Appeal ID: 24657		Project Address: 3846 NW Yeon Ave		
Hearing Date: 2/24/21		Appellant Name: Anna Cunningham		
Case No.: B-013		Appellant Phone: (971) 280-8663		
Appeal Type: Building		Plans Examiner/Inspector: Renay Radtke-Butts		
Project Type: commercial		Stories: 2 Occupancy: Majority S-1, also B Construction Type: V-B		
Building/Business Na	me:	Fire Sprinklers: Yes - Throughout		
Appeal Involves: Erec structure,Reconsiderati		LUR or Permit Application No.: 20-190132-000-00-CO

-	n: pdf [File 1] [File 2] [File 3] 6] [File 7] [File 8] [File 9]	Proposed use: Industrial warehouse		
Appeal item 1 Code Section	OSSC 507.5, OSSC 602, OSSC 70	5.2, OSSC 705.8		
Requires	OSSC 507.5 – Setback requirements for two-story unlimited area buildings.			
	OSSC 602 – Wall rating requirements at the wall based on fire separation distance, construction			
	type and occupancy type.			
	OSSC 705.2 – Projection allowances based on fire separation distance.			
	OSSC 705.8 – Percentage of opening allowances at the wall based on fire separation distance			
	and sprinkler system.			
Code Modification or	ORIGINAL TEXT:			
Alternate Requested	As an alternate method of complying with the above noted sections

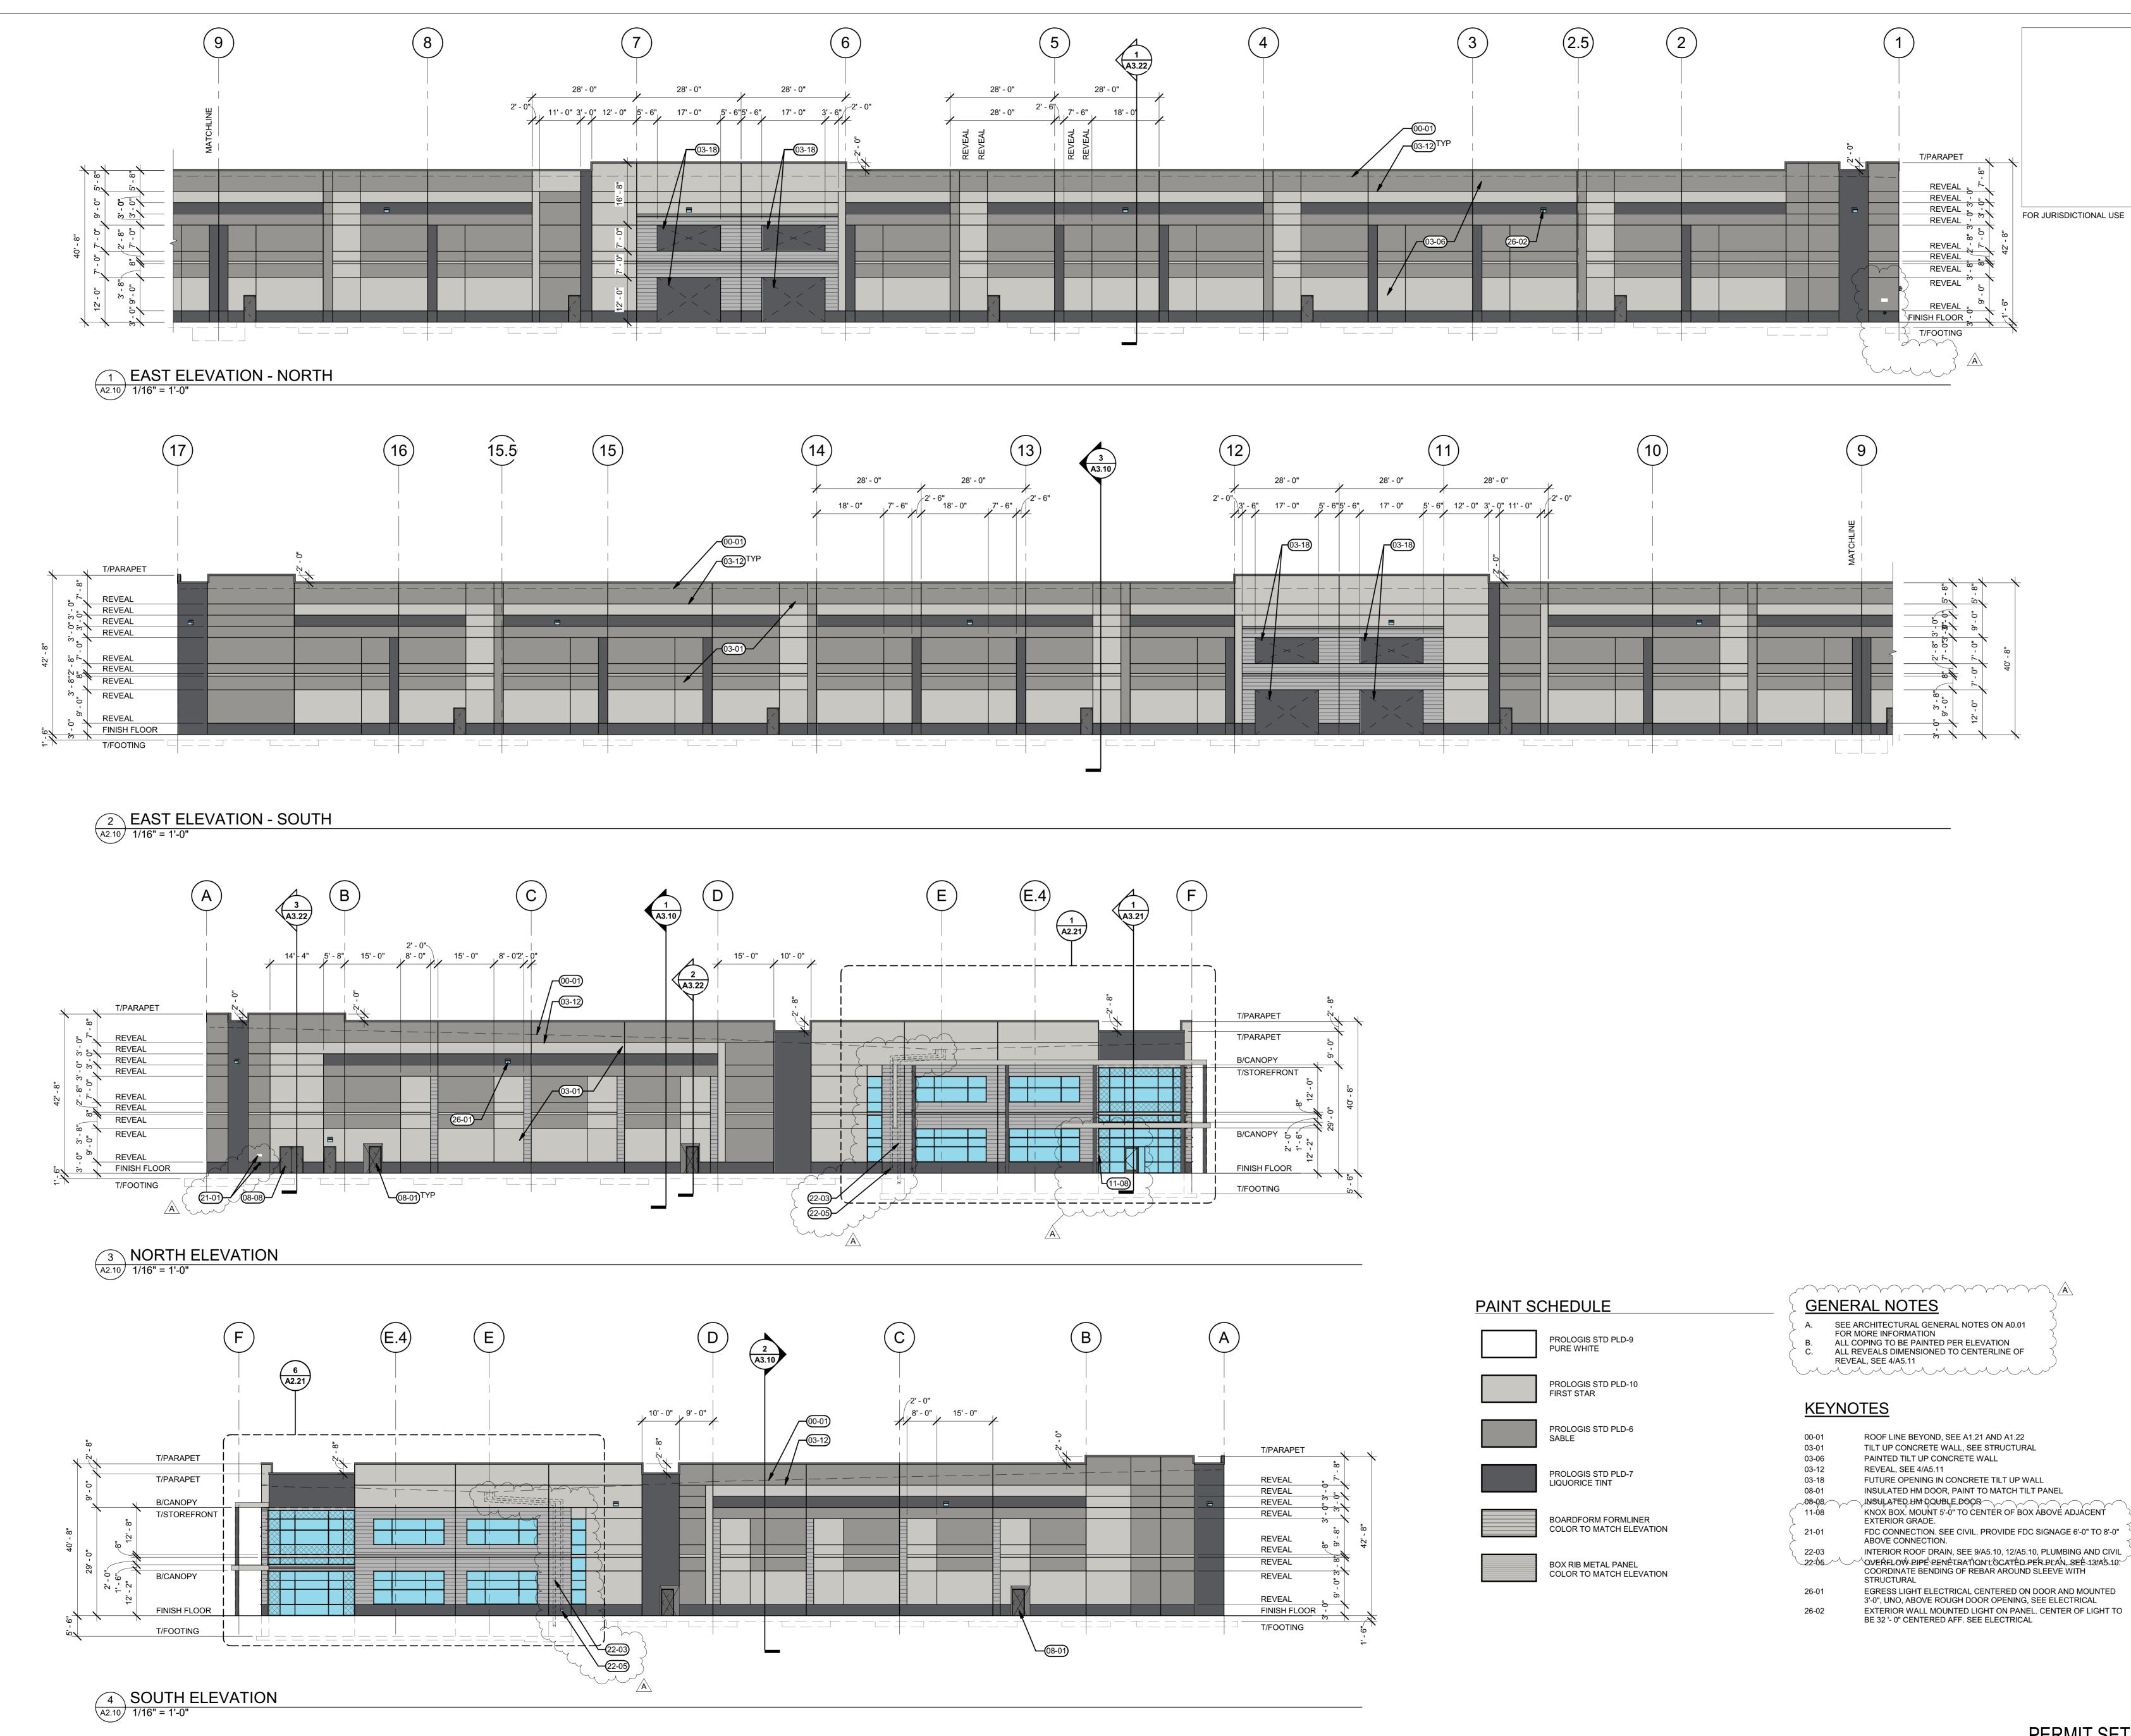
1b. Unlimited area building with minimum 60 foot fire separation distance provided by use of no build easement on South adjacent property:

Granted provided the 13 foot easement is continuous along the South lot line.

Appellant must contact Nancy Thorington (503-865-6438) for more information prior to writing the no build easement.

The unrecorded easement must be reviewed and approved by BDS prior to recording. A copy of the recorded easement must then be provided to BDS prior to plan review approval.

# CODE ANALYSIS OVERALL PLAN

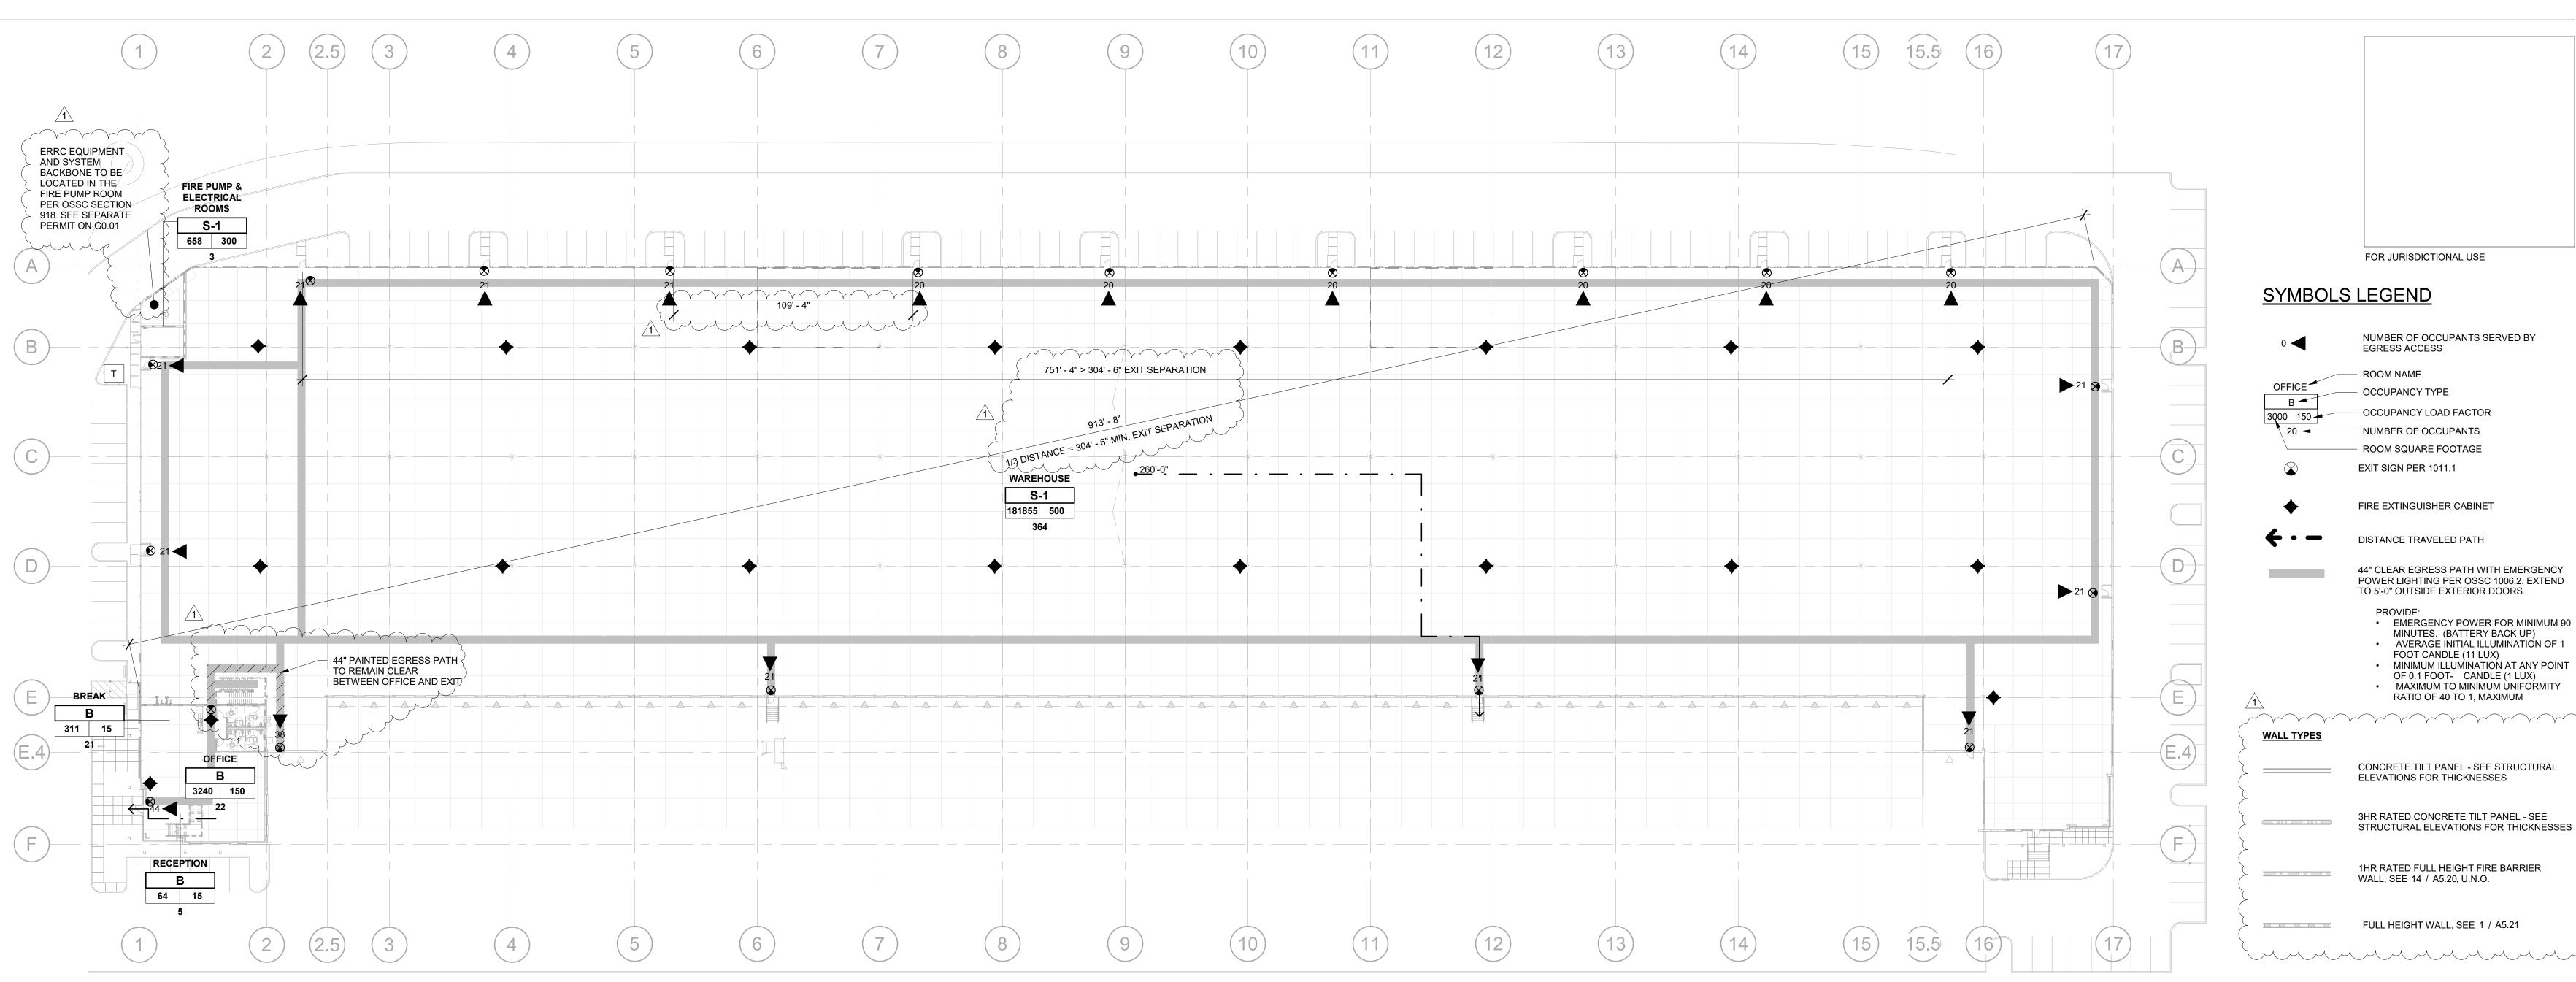
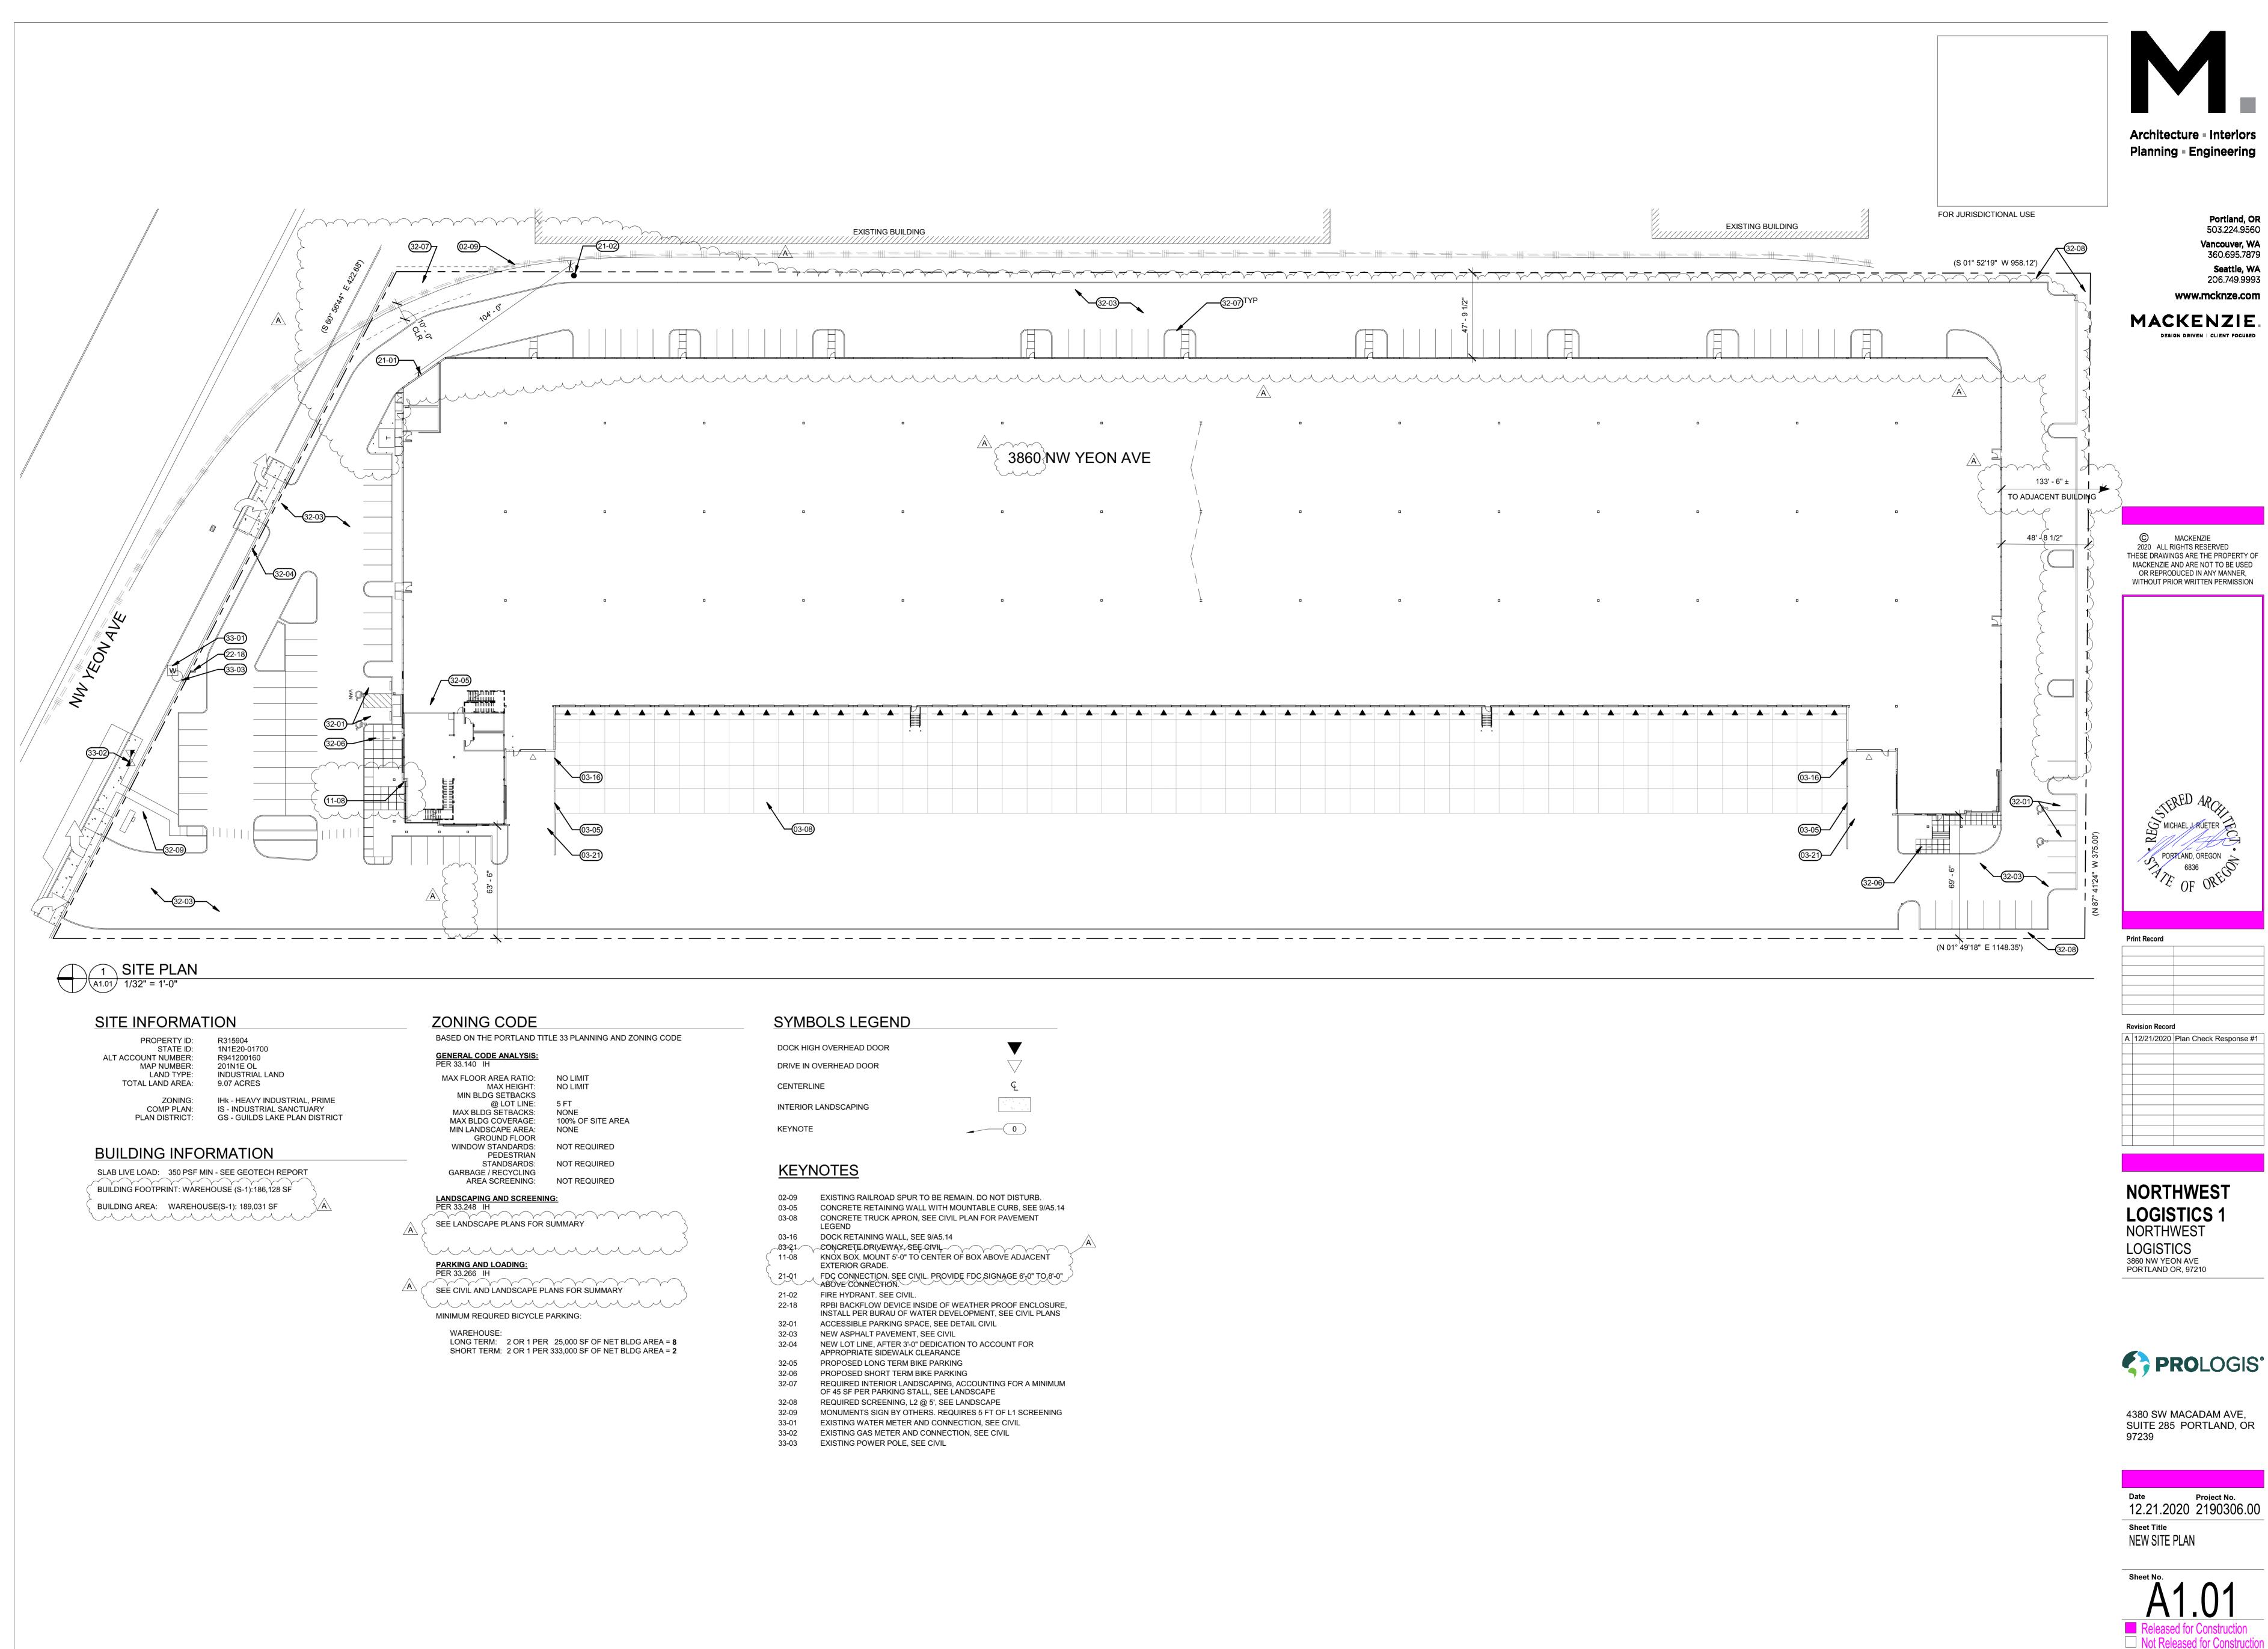
EXCEPTIONS - BUILDING HAS LESS THAN 60' YARDS ON EAST AND SQUTH SIDE TO THE PROPERTY LINE, IN ORDER TO MEET REQUIREMENT OF 507.5 ON THE SOUTH SIDE A CODE APPEAL (ID: 23979) HAS BEEN SUBMITTED  $_{\sim}$ WITH A NO-BUILT EASEMENT WITH THE ADJACENT PROPERTY OWNER TO MAINTAIN THE 60' OPEN SPACE.

THE EAST WALL OF THE BUILDING IS A 3-HOUR WALL WITH 3-HOUR OPENING PROTECTIVES COMPLIANT WITH SECTION 507.2.1 FOR REDUCED OPEN SPACE OF AT LEAST 40' FOR NOT MORE THAN 75% OF THE PERIMETER OF THE BUILDING
